**SUBJECT: RESPONSE TO DISAPPROVAL, TA-63 TRANSURANIC WASTE FACILITY
PERMIT MODIFICATION REQUEST, REVISION 1.0, LOS ALAMOS
NATIONAL LABORATORY, EPA ID #NM 0890010515, LANL-11-045**

**RESPONSE TO NOTICE OF DISAPPROVAL
TA-63 TRANSURANIC WASTE FACILITY
PERMIT MODIFICATION REQUEST, Rev. 1
LOS ALAMOS NATIONAL LABORATORY**

**RESPONSE TO THE
DISAPPROVAL, TA-63 TRANSURANIC WASTE FACILITY
PERMIT MODIFICATION REQUEST
REVISION 1.0
LOS ALAMOS NATIONAL LABORATORY
EPA ID# NM 0890010515
LANL-11-045**

Attachment F
Revised Permit Figure 55

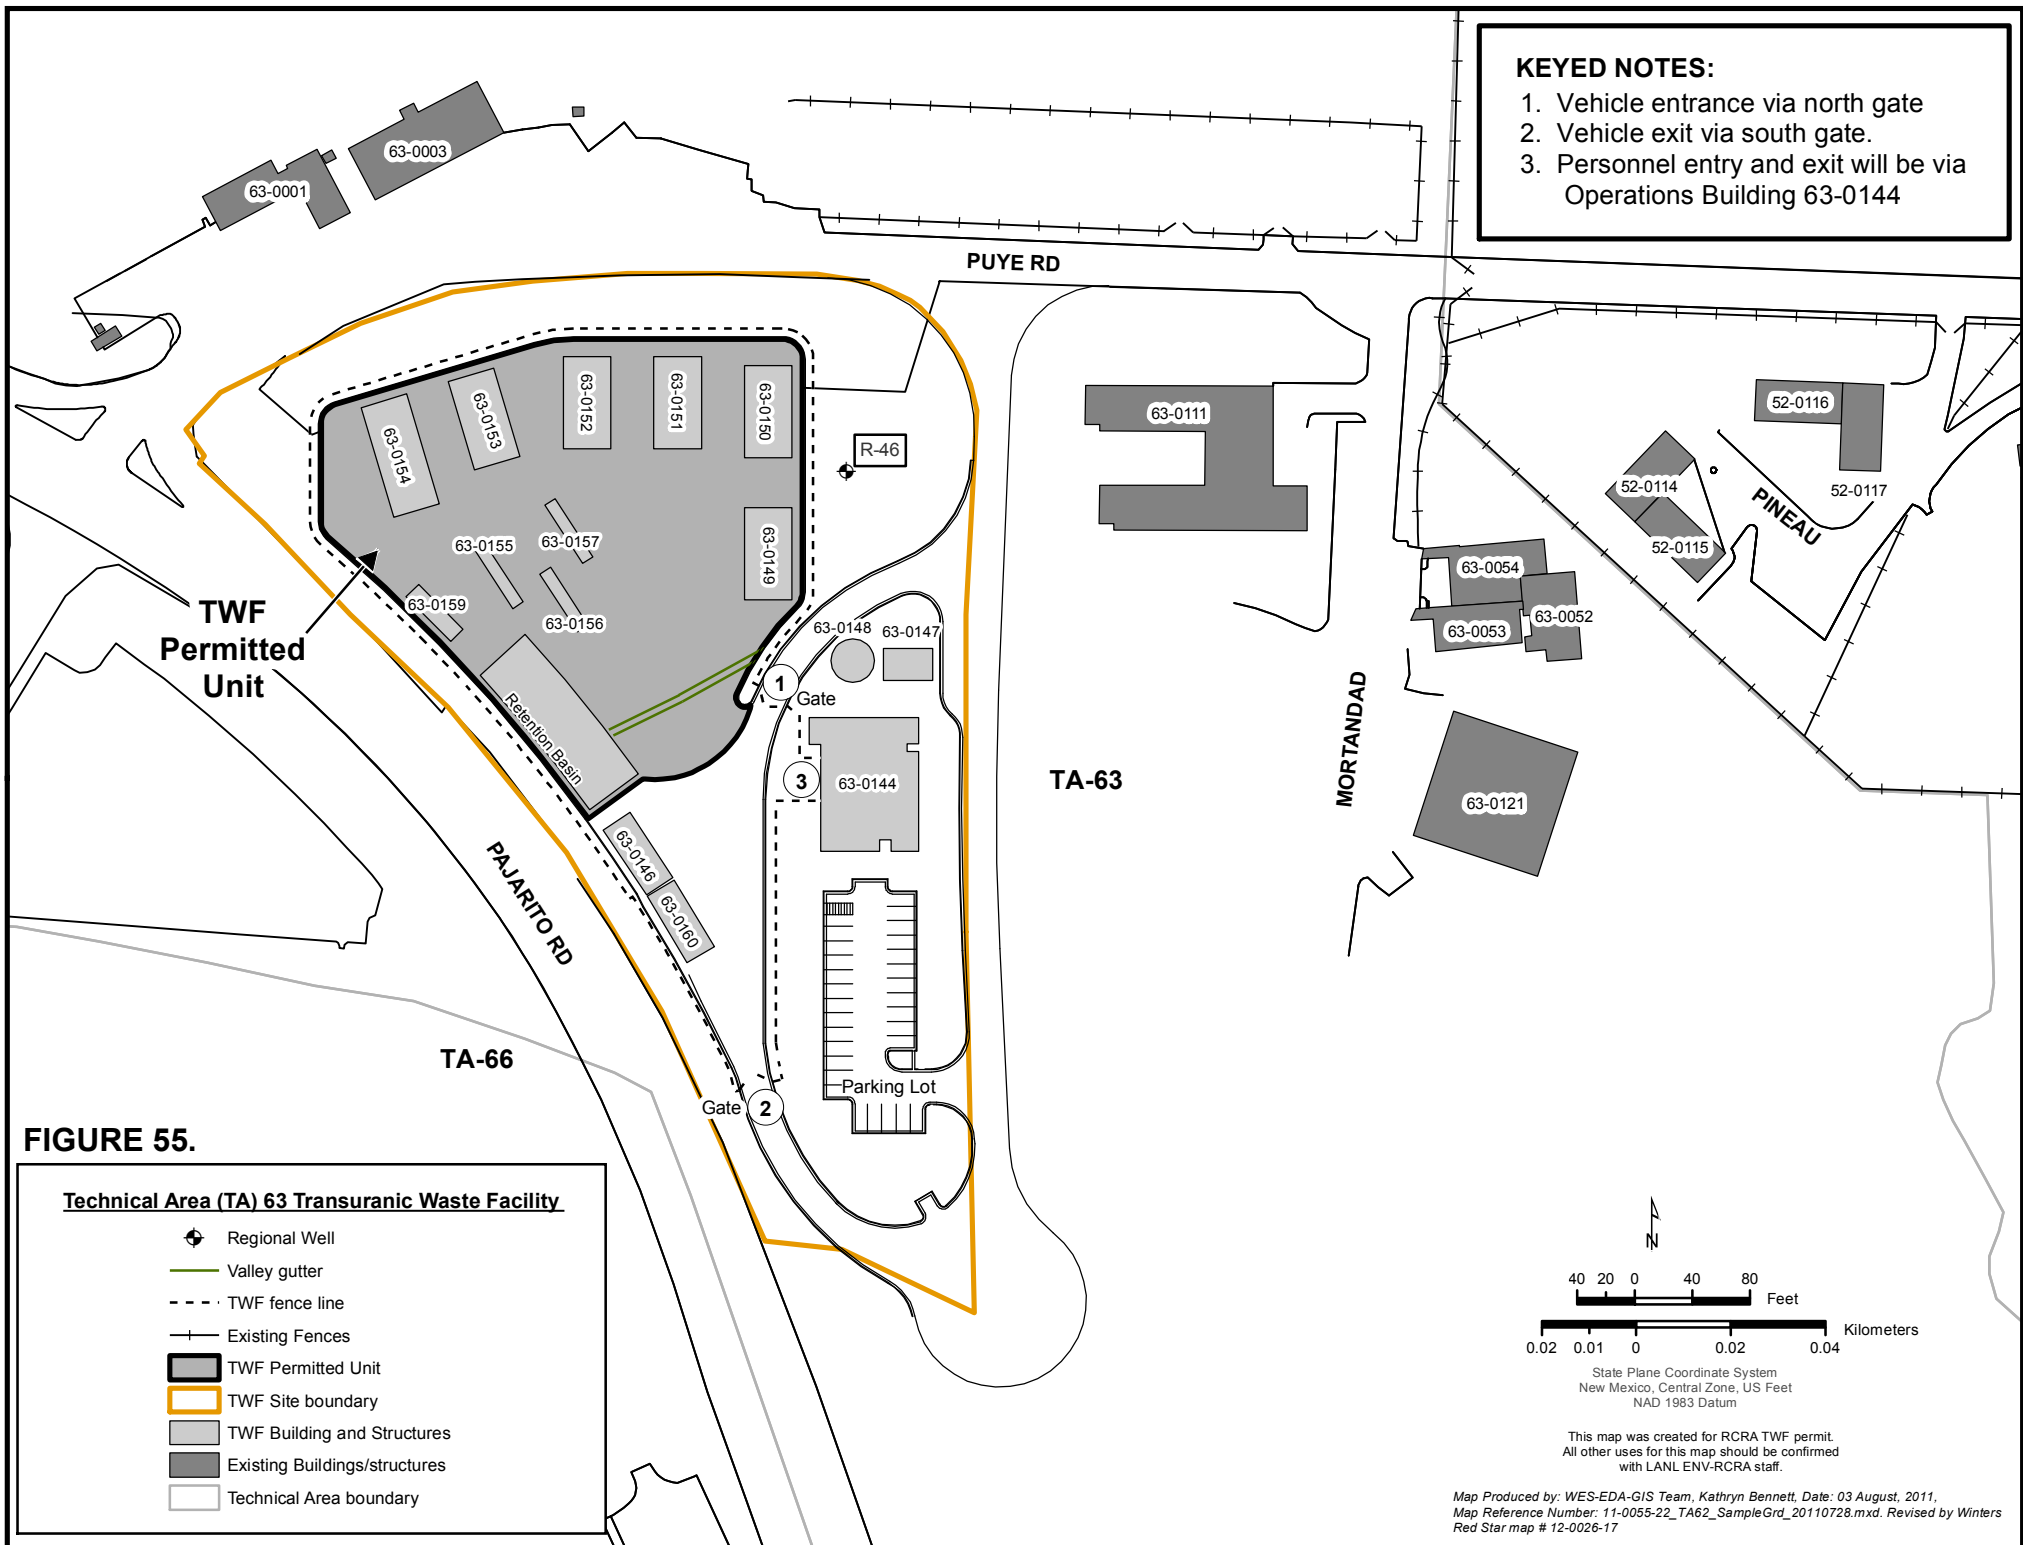
24. *Proposed Section 2.5 states that entry stations are shown in Figure 55; however, Figure 55 does not identify the entry stations. Revise the figure to include the locations of the entry stations.*

Figure 55 has been revised to include personnel access into the unit from the Operations Support Building. Revised Figure 55 is included in Attachment F of this document.
